Meeting Date: Tuesday 5 November 2013
Location: Committee Room 2, Level 5, Civic Centre, 1 Devlin Street, Ryde
Time: 5.00pm

Item		Page
1	CONFIRMATION OF MINUTES - Meeting held on 15 October 2013	1
2	6 YARWOOD STREET, MARSFIELD - LOT 10 DP 234293 Development Application for demolition and new dual occupancy (attached). LDA2013/0073. <i>INTERVIEW 5.00PM</i>	5
3	51 BAYVIEW STREET, TENNYSON POINT - LOT 2 in a Subdivision of LOT 103 DP 1003228. Development application for two storey dual occupancy (attached) including two swimming pools. LDA2012/0478. <i>INTERVIEW</i>	64

2 260-274 VICTORIA RD, GLADESVILLE. Lot 62 to Lot 67 DP 10598. Local Development Application for demolition and construction of a mixed use building containing 26 residential apartments and 3 retail tenancies. LDA2012/0360.

Plan showing highly articulated streetscape façade to Coral Street

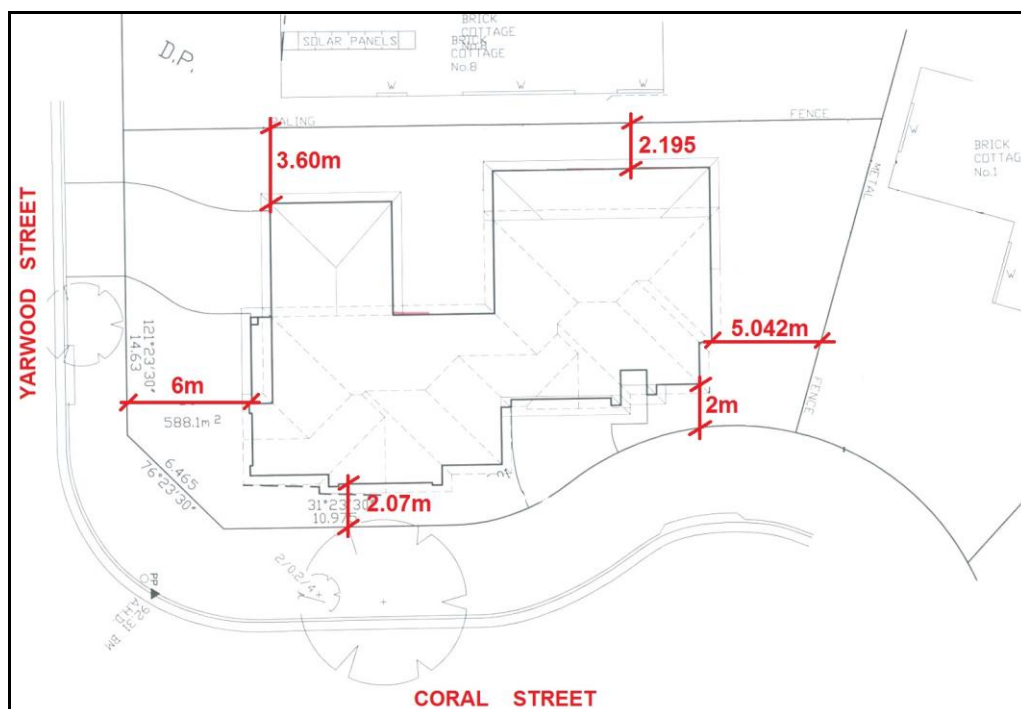
Comment: The existing dwelling is single storey, so any 2-storey development will result in an increase in visual bulk compared to the existing situation. However, the design of the development has attempted to minimise visual bulk by not only fully complying with the height requirements of Ryde LEP 2010 and DCP 2010, but also providing a highly articulated façade to the Coral Street frontage (the longer of the 2 street frontages of the subject site), which also steps back to follow the curve in the road frontage to Coral Street, as shown in the drawing below.

Plan demonstrating proposed setbacks (amended plans)

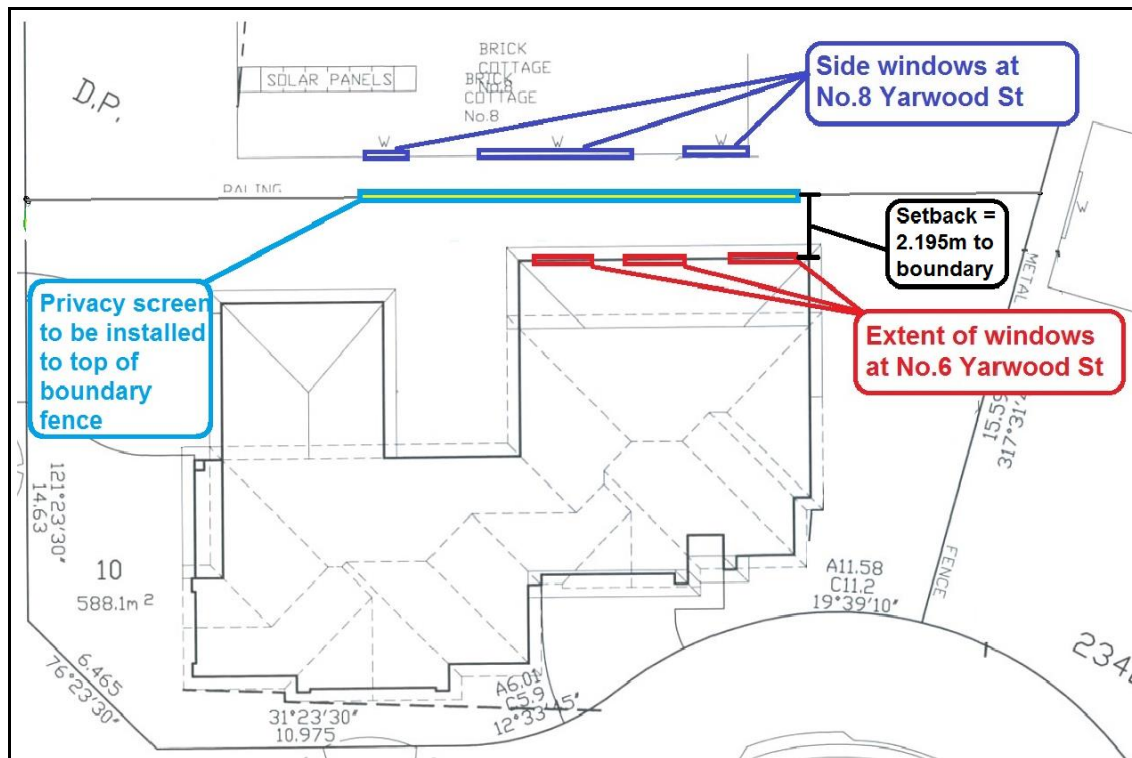
Given the highly irregular allotment shape of the subject site and the fact that the dual occupancy has two dwellings facing two different streets, strict application of the DCP controls are not considered to result in an outcome that reflects the setback control objectives. It is noted that the Ryde DCP 2010 does not provide any specific setback controls for dual occupancies on a corner allotment, thus a merit based assessment is required.

Although the development still does not fully comply with the rear setback requirement of 8m or 25% of the length of the site whichever is greater (ie 8.75m required at this site), the proposal is considered to be acceptable as discussed further in the DCP compliance section of this report.

With the irregular allotment shape it is considered very difficult to maintain a street setback that is both consistent throughout the length of the boundary and consistent with the neighbouring allotments. While it may initially seem that a 2m setback from Coral Street is minimal, it must be noted that Section 2.8.1 of the Ryde DCP 2010 prescribes that on corner allotments, the setback along the secondary street is to be a minimum 2m. Accordingly even if the subject site was developed for the purposes of a dwelling house, a comparable setback and visual built form on the Coral Street frontage would be experienced.

Figure 15 – Plan demonstrating proposed level of overshadowing

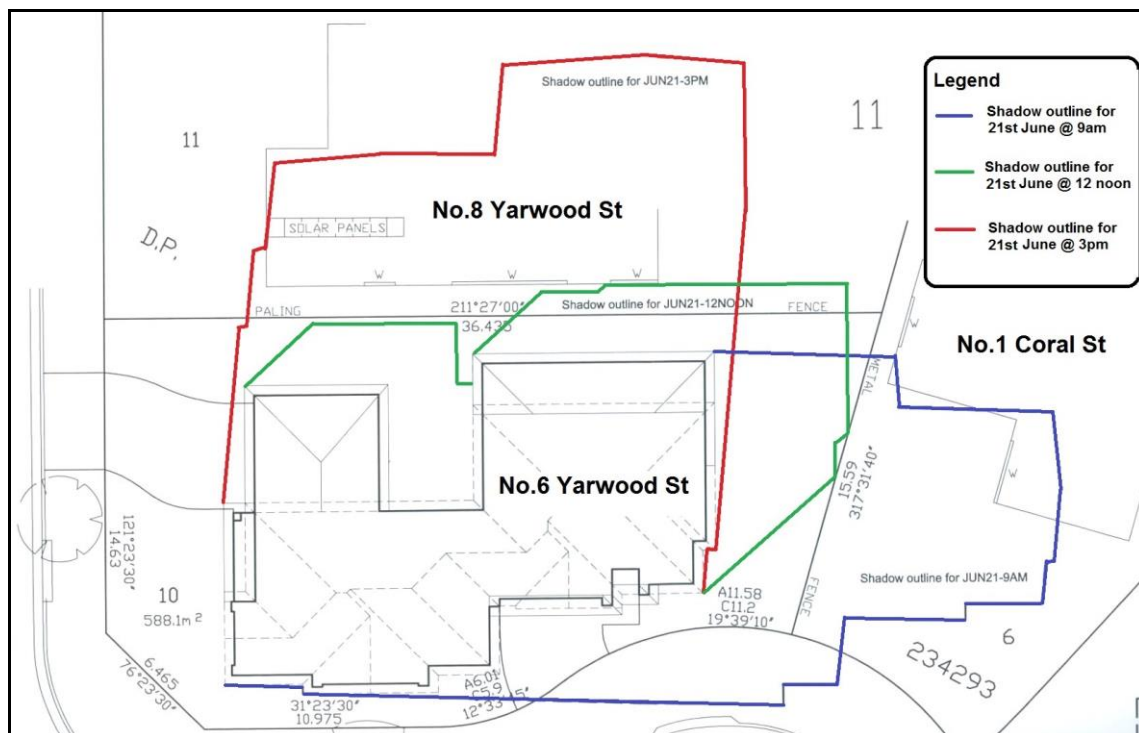
With regards to the solar panels located on the roof of the dwelling at No.8 Yarwood Street it is considered that these will not be overshadowed until approximately 1:30pm on the 21st of June, therefore seeing them receive a considerable level of sunlight access. Furthermore it is noted that the shadows shown in Figure 9 below will be the worst case scenario with shadows being less severe at other times throughout the year.

Accordingly, it is considered that the overshadowing impacts of the proposal are acceptable.

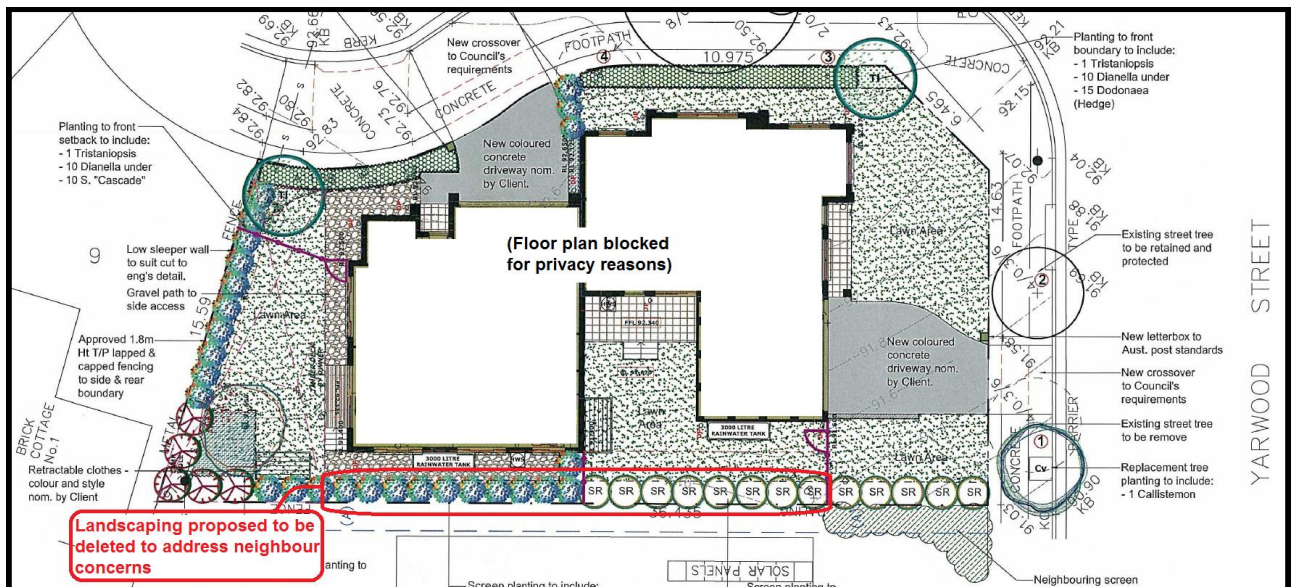
- L. Screen Planting** – concerns are raised regarding the row of proposed screen planting along the south-eastern boundary and the impact this will have to the neighbouring dwelling in terms of reducing available light, blocking gutters with debris and diminishing airflow.

Comment: The proposed location and species selection would normally be considered appropriate given the visual privacy concerns raised by the neighbouring allotment at No.8 Yarwood Street.

Deletion of Boundary Screen Planting. Boundary screen planting shown of the Landscape Plan prepared by Conzept Landscape Architects dated 08.07.2013 Revision E of eight (8) *Syzygium 'Resilience'* in the rear yard of Dwelling A and eight (8) *Syzygium 'Cascade'* within the rear yard of Dwelling 'B' adjacent to the dwelling at No.8 Yarwood Street are to be removed. Details of compliance are to be provided in the plans for the **Construction Certificate**.

Height and location of proposed fill

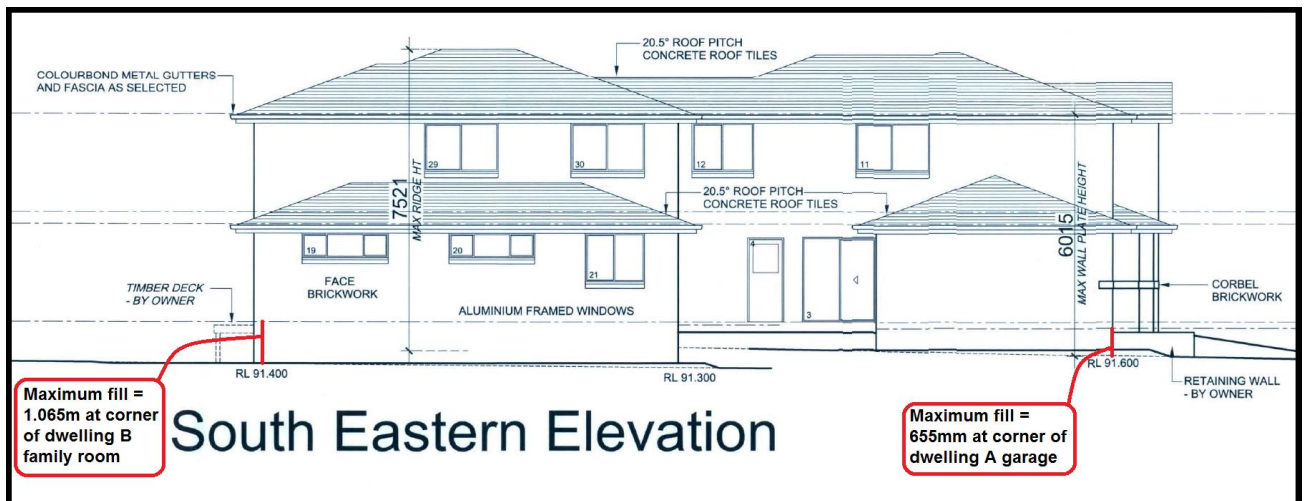
An assessment of the cut and fill arrangements for the proposed development have revealed that the proposed level of fill within the building footprint is 1.065m and proposed level of fill outside the building footprint is 655mm, as shown in the south-east elevation below.

- Issues of privacy and overlooking with regards to fill outside the dwelling footprint are not considered to be significant due to area of non-compliance relating to outside the garage. Additionally, screen planting has been implemented adjacent to the area of non-compliance to further mitigate and privacy impacts.

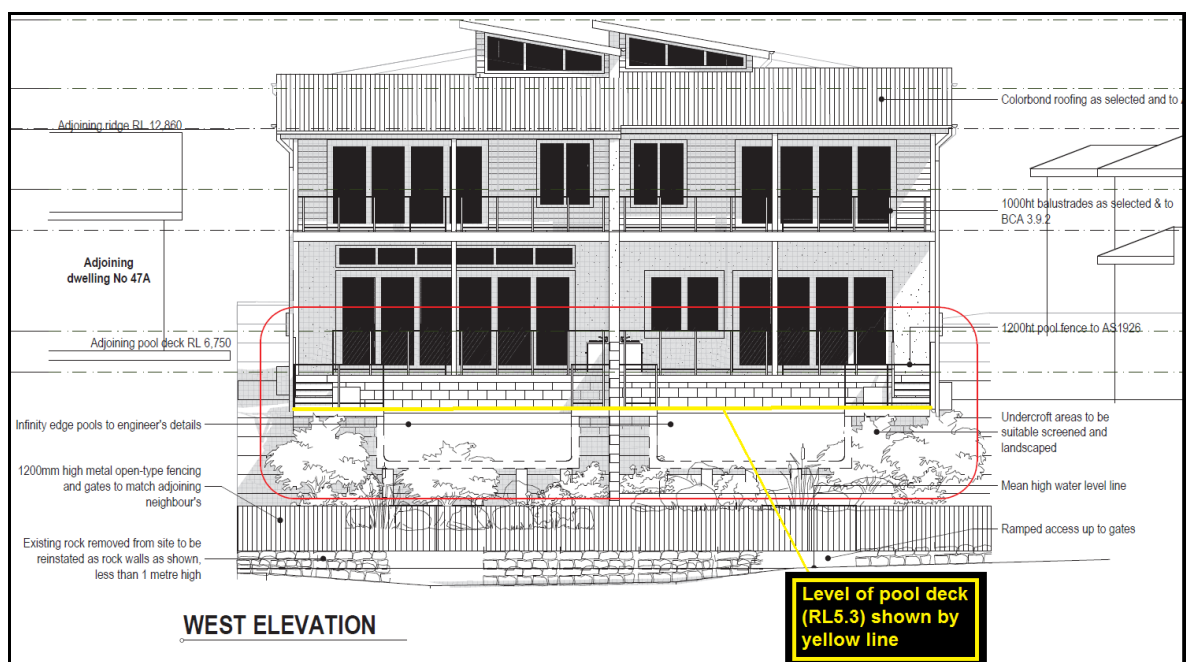
- C. *Swimming Pool and Deck*** – *Concerns are raised regarding the swimming pool and deck area providing for overlooking to the neighbouring pool and garden area.*

Comment: In Council officer's assessment of the original development application plans, visual privacy impacts from the swimming pool and deck area were identified as a potential issue due to their height above that of the neighbouring allotment at No.53A Bayview Street.

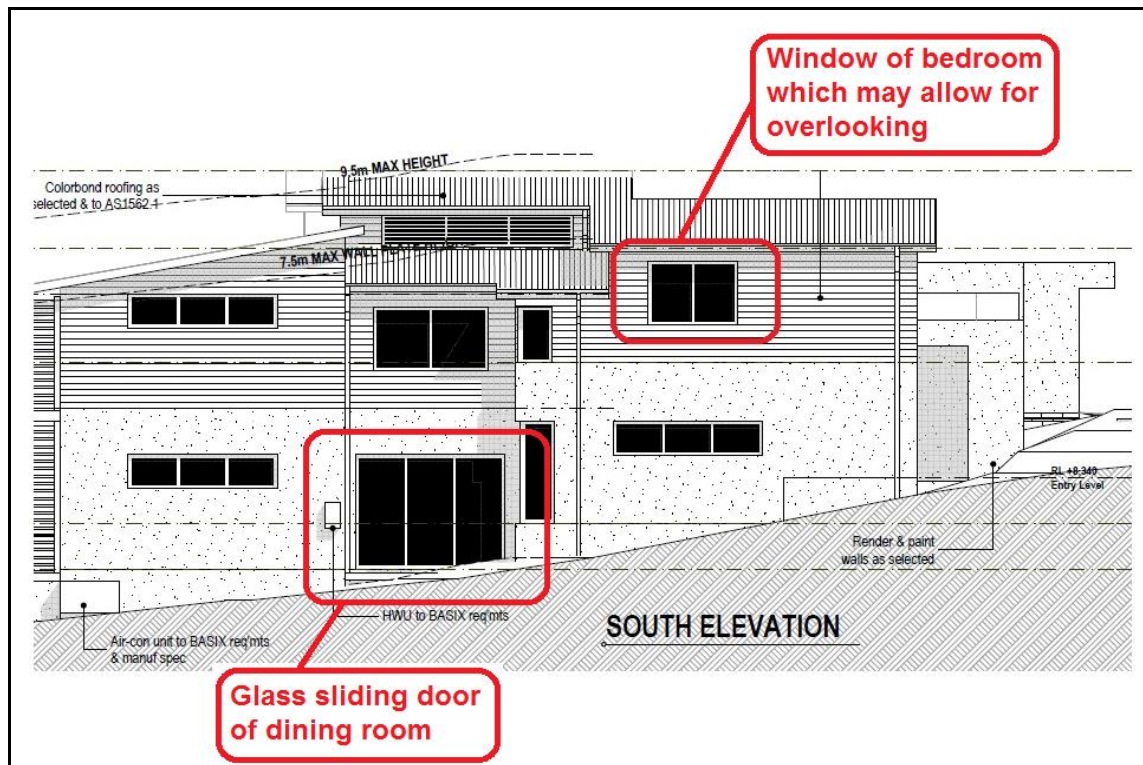
- E. ***Visual Privacy Impacts from Bedroom Windows*** – concerns are raised regarding the window of bedroom No.3 of Unit 2 impacting upon the privacy of the neighbouring dwelling.

Comment: Visual privacy issues from the windows of Bedroom 3 of Unit 2 is considered to be a valid issue of concern due to their location aligning with windows of the objector's property.

South Elevation showing wall plate height at South Elevation

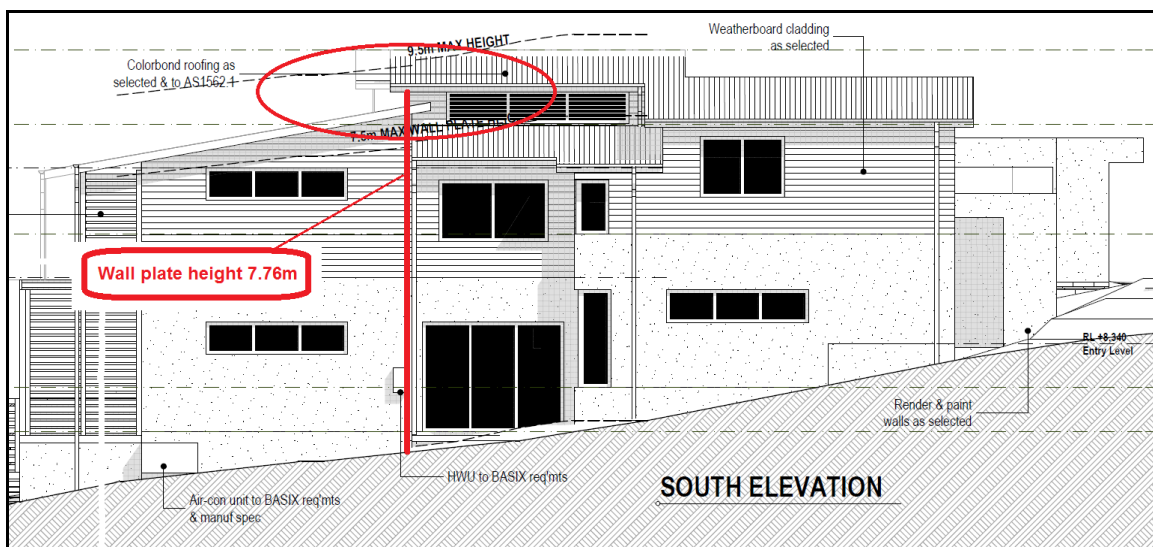
The proposal has a wall plate height along part of its section of 7.76m, therefore exceeding the maximum by 260mm at the highest point, which is towards the centre of the building when viewed at the south elevation – see below.

Assessing Officer's Comment: Although exceeding the maximum wall plate height permitted for the site by 260mm, *given* that the proposed development is generally consistent with Ryde's planning controls relating to overall building height, floor space ratio, setbacks, overshadowing and privacy impacts, this non-compliance is considered to be justifiable.
